3UR-FE Accessory Drive Belt Tensioner

Service Category Engine/Hybrid System

Section Engine Mechanical

Figure 1.

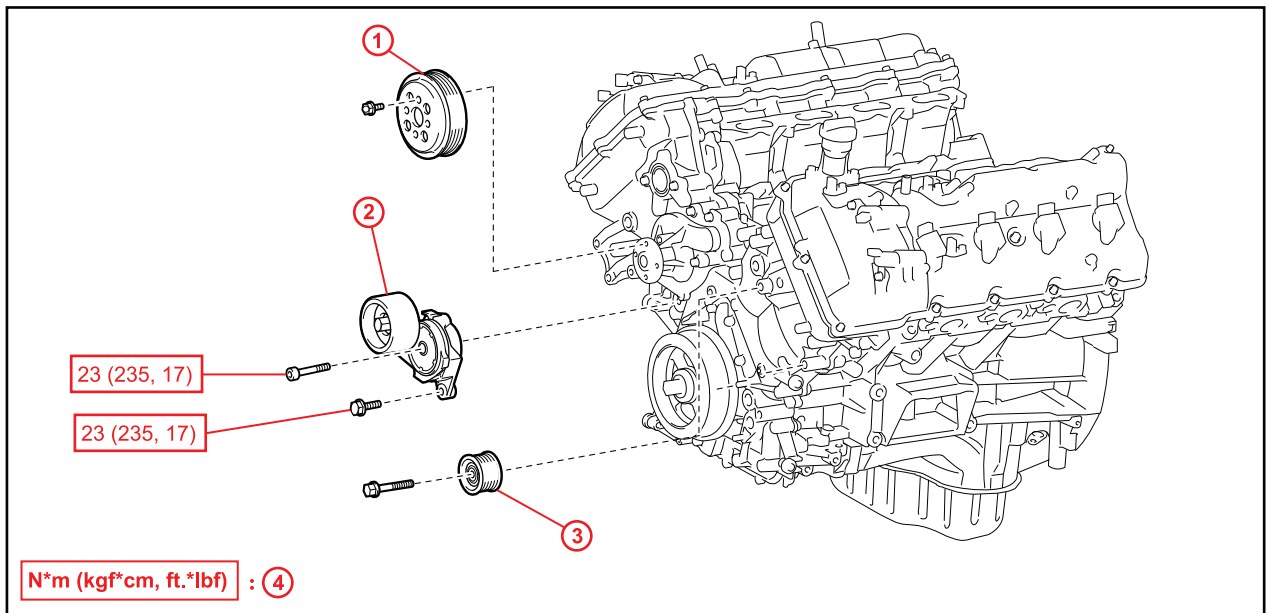
Some customers may experience an abnormal noise from the engine accessory drive belt area. An improved accessory drive belt tensioner assembly has been developed to keep the tensioner pulley in alignment with the other pulleys. If the tensioner pulley is out of alignment, use the procedure in this bulletin to address the customer's concern.

2. Remove the drive belt tensioner assembly.

3. Replace the drive belt tensioner assembly.

Torque: 23 N*m (235 kgf*cm, 17 ft*lbf)
